#### CHARTER TOWNSHIP OF VAN BUREN PLANNING COMMISSION AGENDA Wednesday, October 13, 2021 – 7:30 PM REMOTE MEETING –AGENDA

# ITEM # 1 Case 21-021- General Development Company, LLC - Special Land Use request

#### ITEM # 2 Case 21-021- General Development Company, LLC – Preliminary Site Plan

TO:Van Buren Township Planning CommissionFROM:Dan Power- Director of Planning and Economic DevelopmentRE:Case 21-021: General Development Company, LLC - Special<br/>Land Use and Preliminary Site Plan RequestDATE:October 6, 2021

SHEET Engineering Site Plan

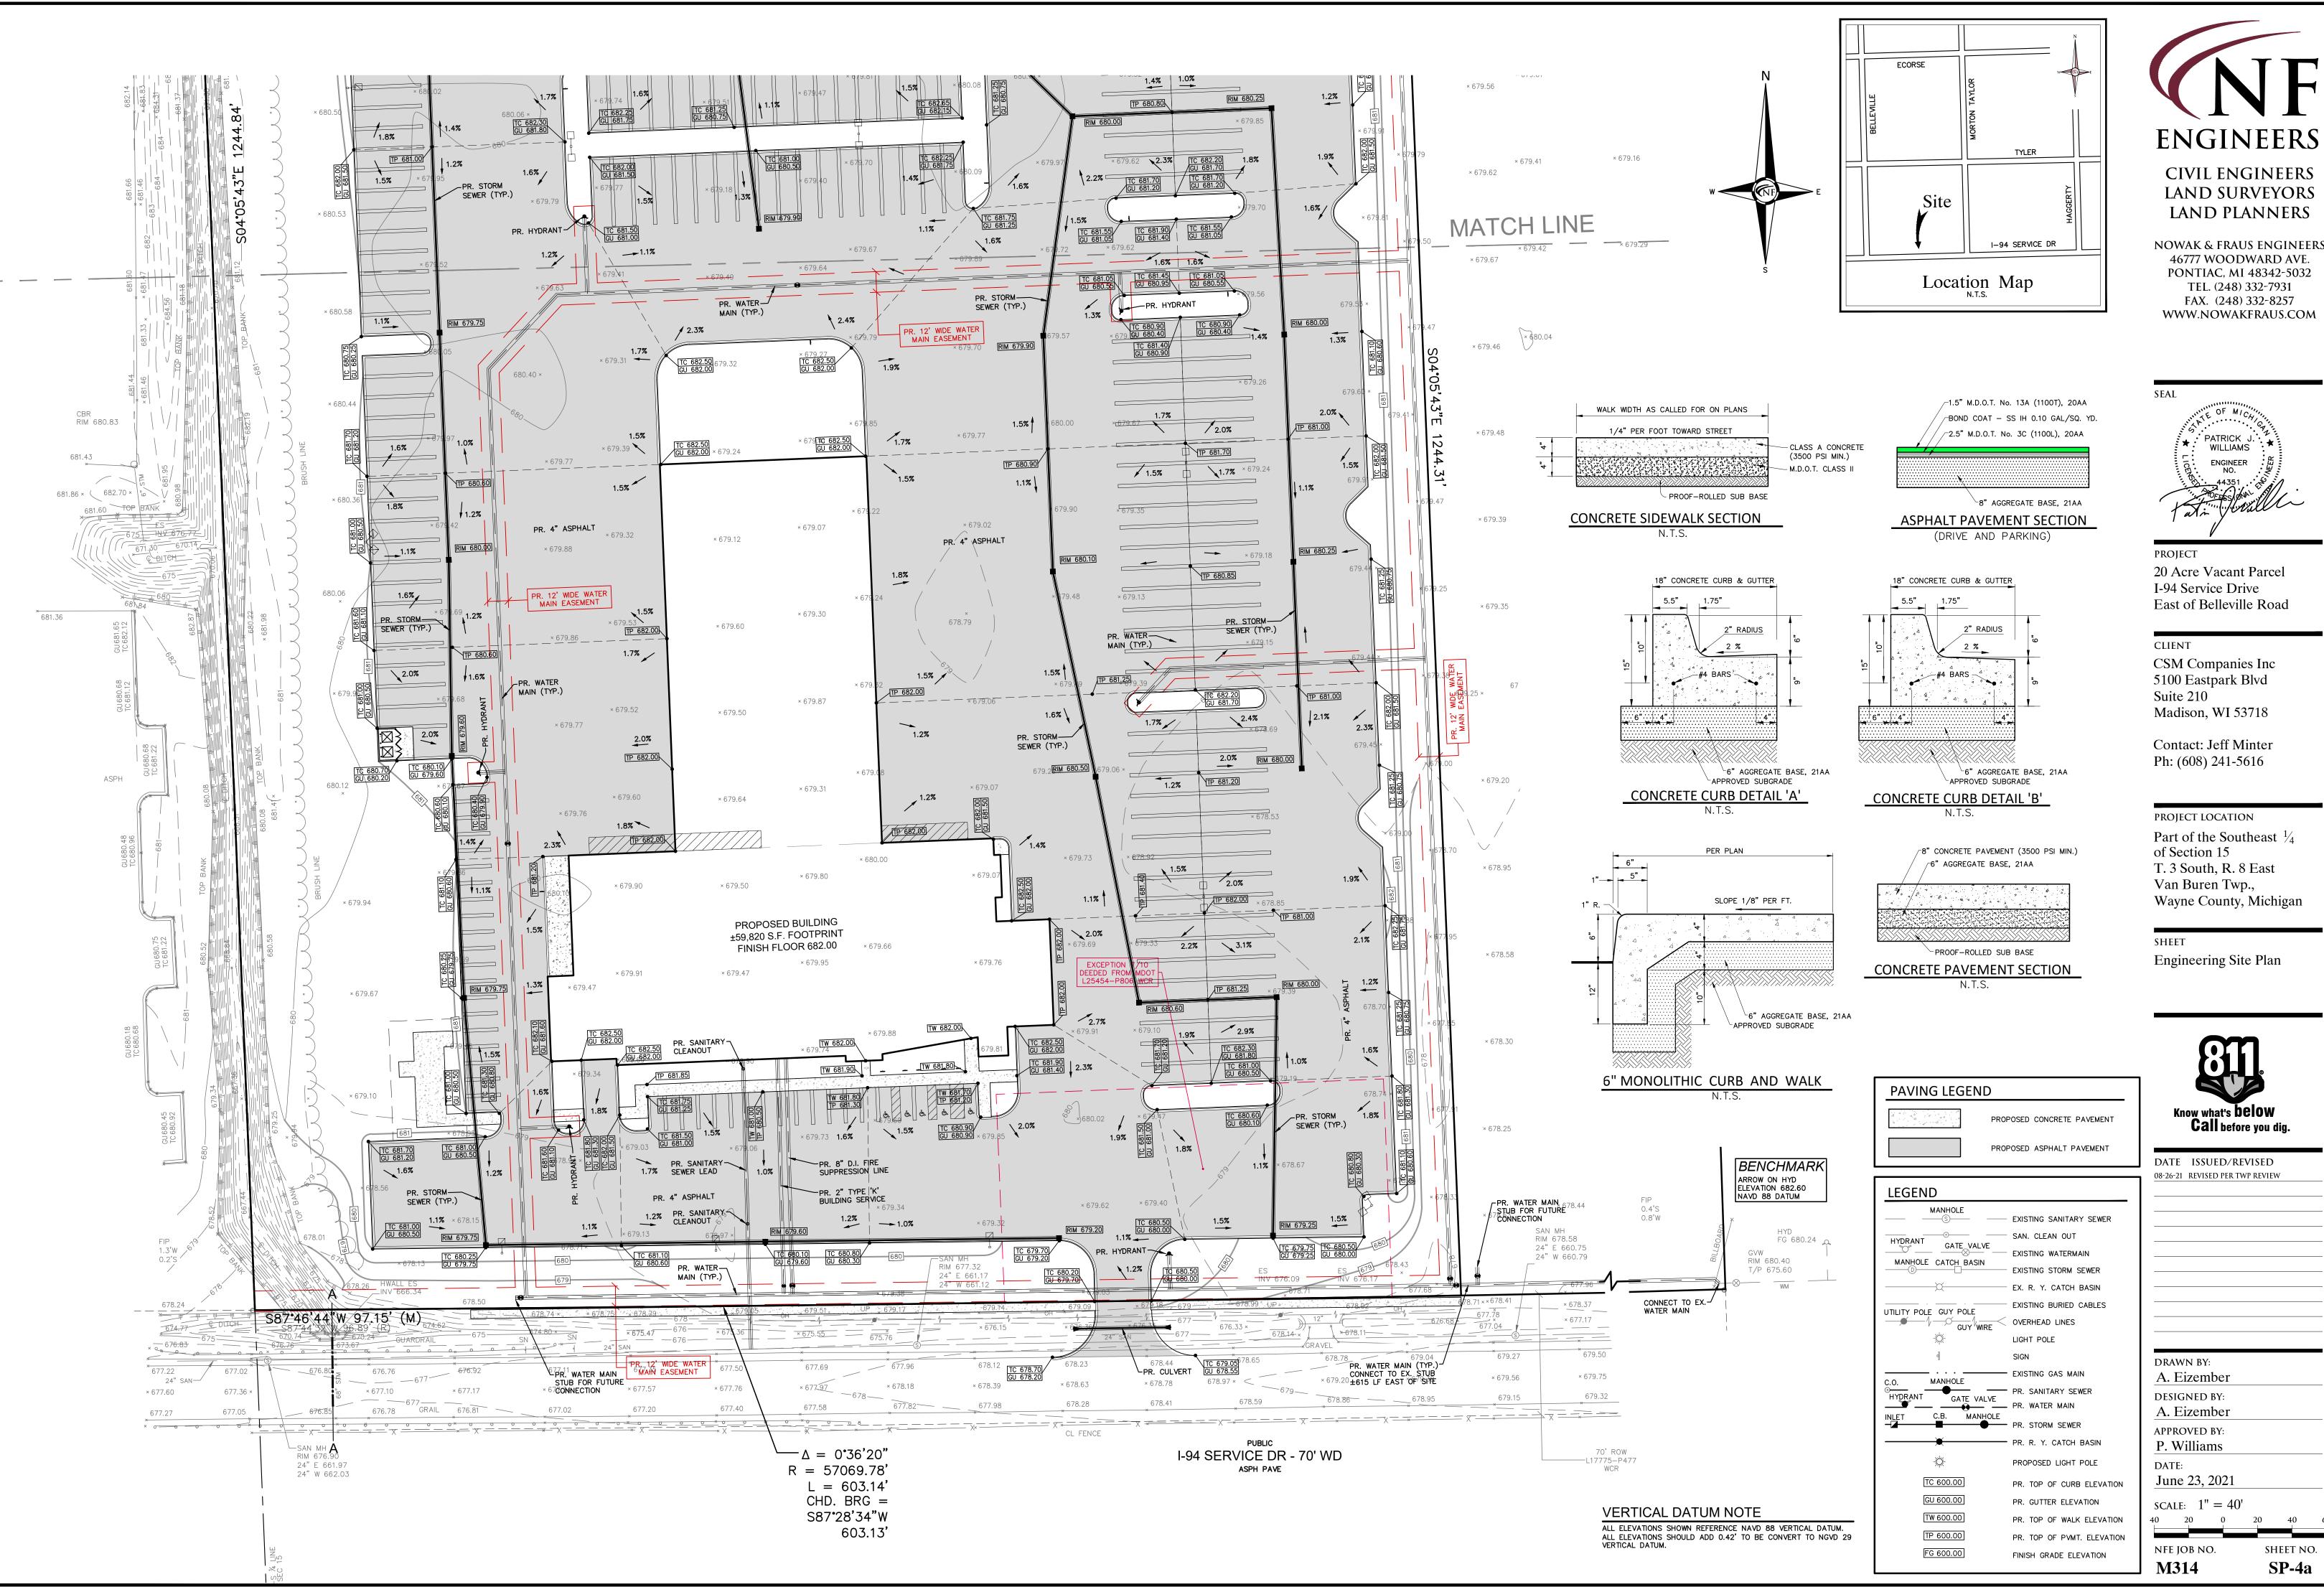
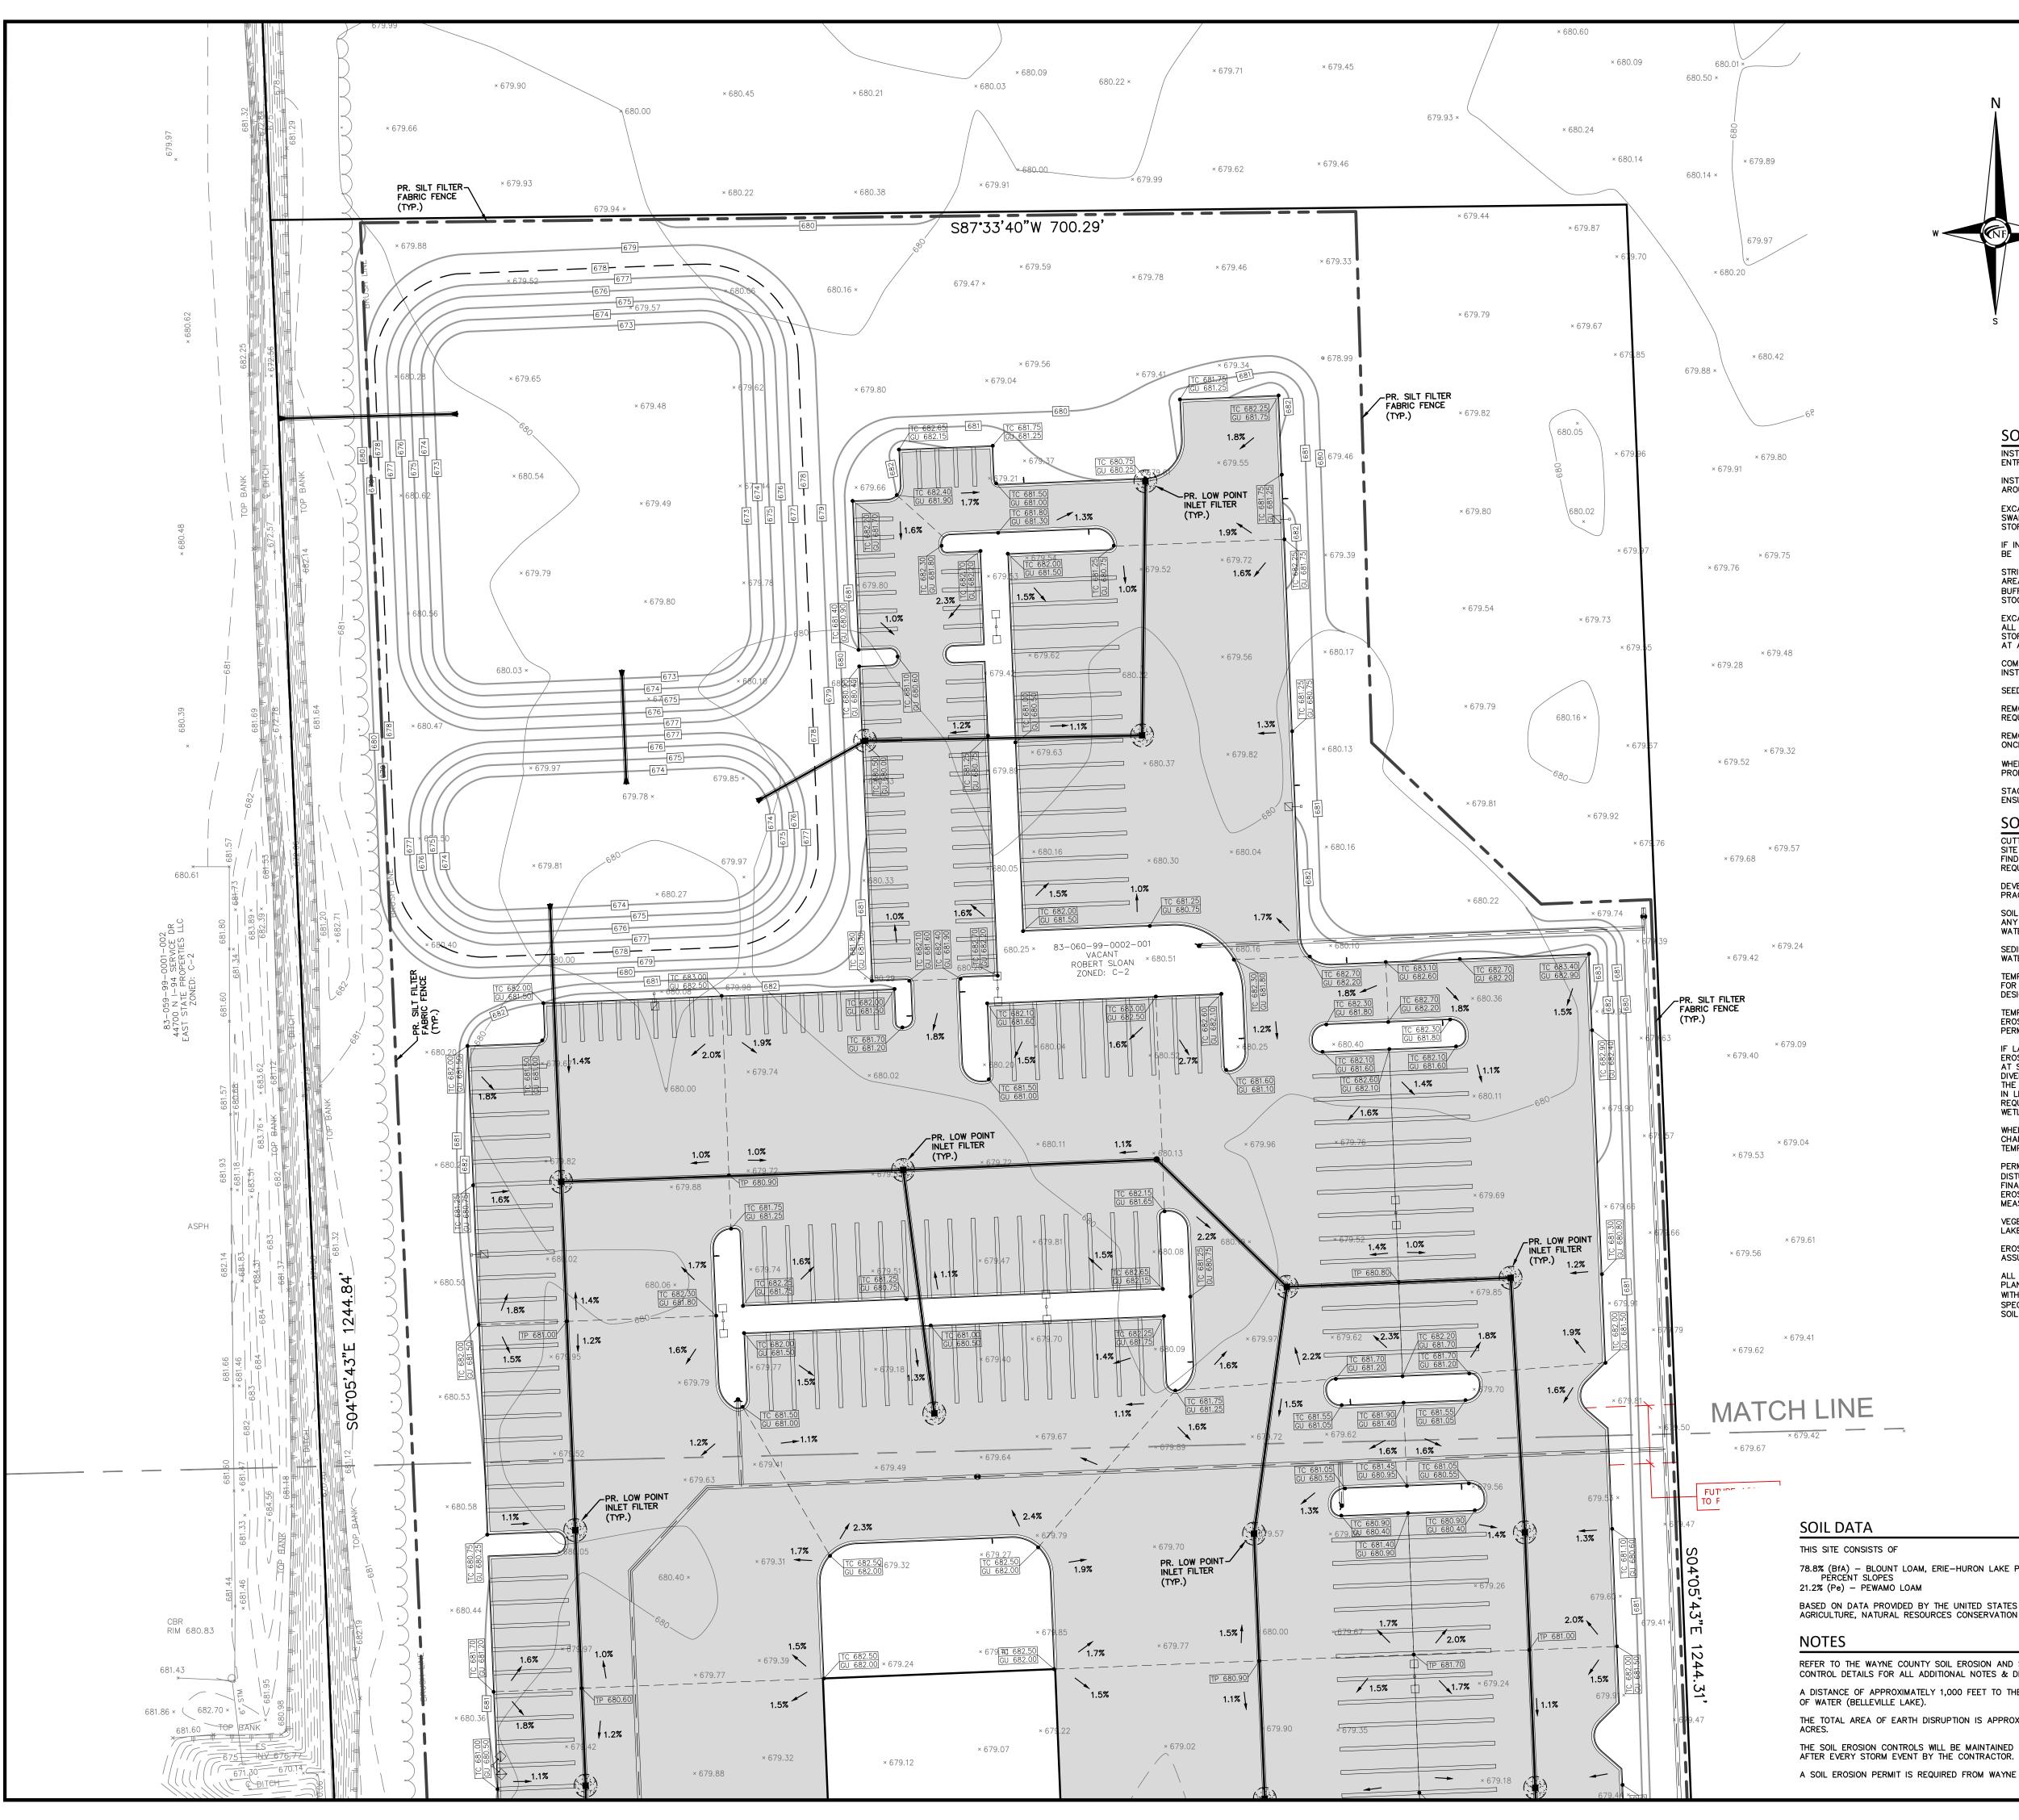
- 4. The calculation for the Total 100 year Volume Storage should be notated as "Vt100", not "Vs100", as shown on sheet SP-4.
- 5. The permanent water elevation within existing ditches and drains should be field measured and indicated on the plans.
- 6. The County owned Quirk Drain should be labeled.
